Subject: Response to Request for Additional Information (RAI) for Relief Request 14-ON-001,  
Letdown Cooler Nozzle Welds (CAC NOS. MF6290, MF6291 AND MF6292)  
(ADAMS Accession No. ML16061A565)

**Oconee Nuclear Station Unit 1, 2 and 3,  
Response to Request for Additional Information (RAI), regarding  
Relief Request 14-ON-001 for Letdown Cooler Nozzle Welds**

Sketch 1

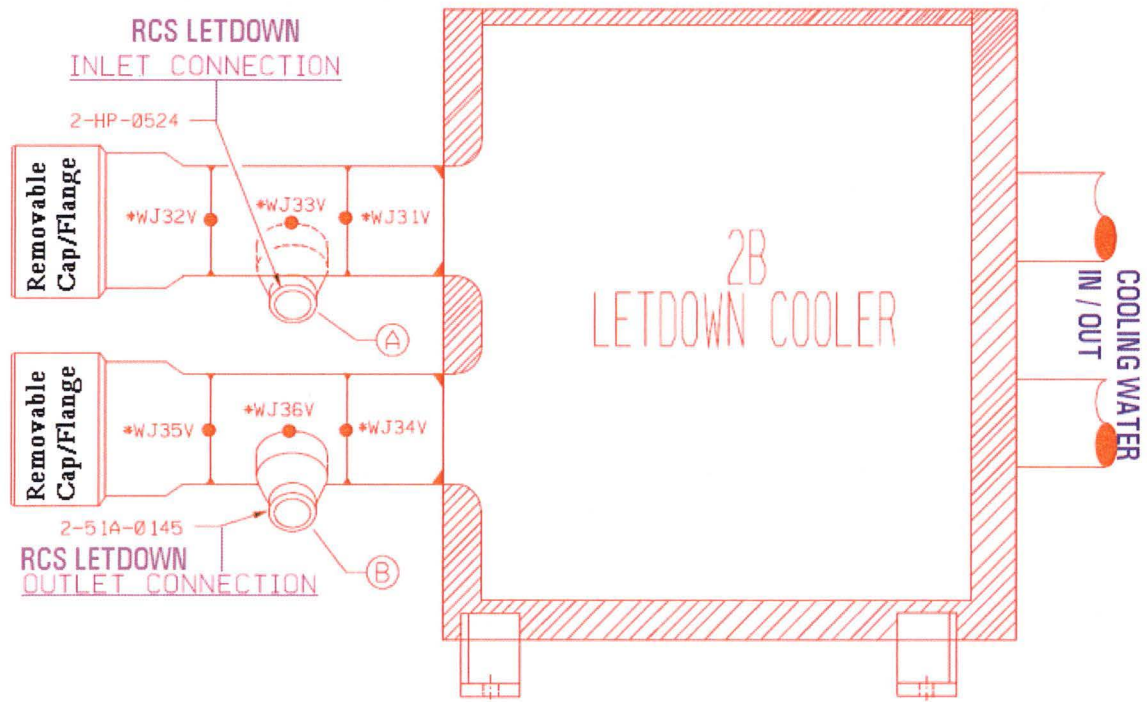
Please provide a more detailed description of the nozzle inside radius sections that are required to be ultrasonically examined per the ASME Code, Section XI, by either referring to the drawings in the relief request as a guide or by providing additional sketches or drawings of the subject welds/nozzles.

The welds WJ33V and WJ36V in Sketch 1 below represent the typical nozzle to cooler welds for all letdown coolers and all units. These welds are inspected per ASME Section XI, Table IWB-2500-1, Exam Category B-D, Item No. B3.150 and are not within the scope of this relief request.

This relief request only applies to inspections for Item B3.160 exams of the inner radius section of the nozzle base material (see Sketch 2 below).

### Sketch 2

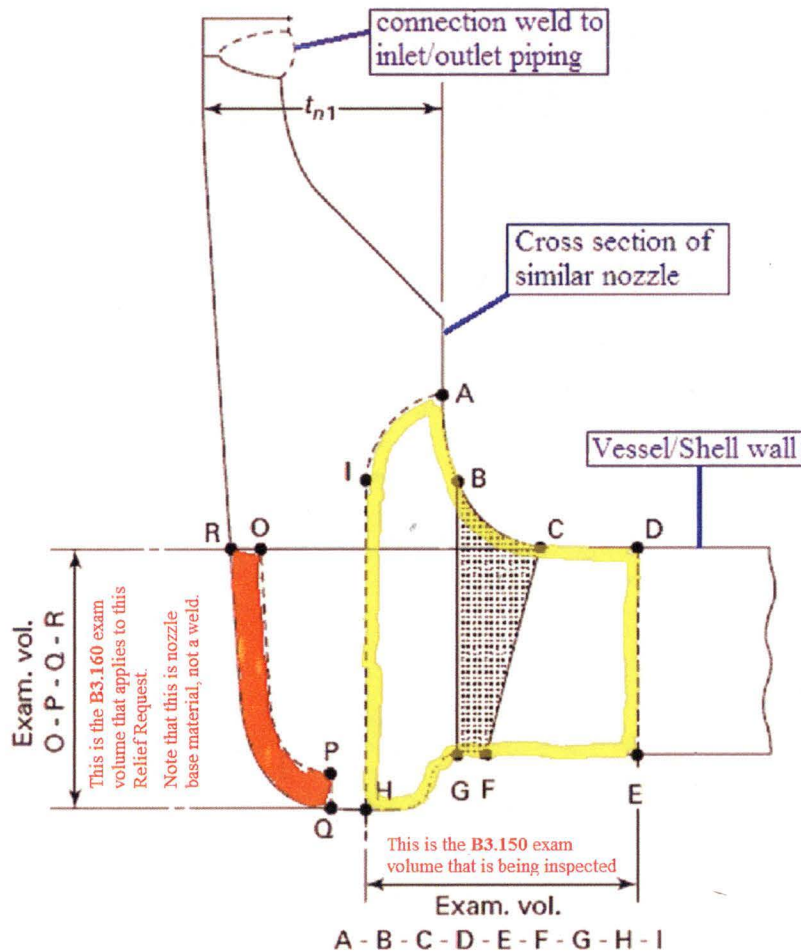
**Section 1 of the relief request states that "...Oconee Unit 1 has two Letdown Coolers 1A and 1B. Each component has typically four B3.160 welds..." Please confirm that the required examination is on the attachment welds of the nozzles, not the nozzles themselves, and that the required examination is on the inside radius of the welds.**

The exam volumes for Category B-D, Items B3.150 and B3.160 are illustrated below (Reference ASME Section XI, Figure IWB-2500-7(a)). Relief Request 14-ON-001 only applies to the exam of Item B3.160, which is the inner radius section (base material). The B3.160 exam volume is adjacent to the B3.150 weld exam volume, but is not a weld exam. (see sketch OM-201.-3276.001, Detail "A" in the relief request.)

As stated and illustrated in RAI 1 above, the Relief Request is limited to the B3.160 exam volume only, which is the nozzle "inner radius" section (i.e., base material). The nozzle-to-cooler weld is inspected as an Item B3.150 exam. Relief is not being requested for the B3.150 exams.

Referring to the nozzle inner radius section (Item B3.160) as locations rather than welds in the original request would have been clearer, but this relief request only applies to the inner radius of the nozzle base material illustrated in RAI #1 as exam volume O-P-Q-R.
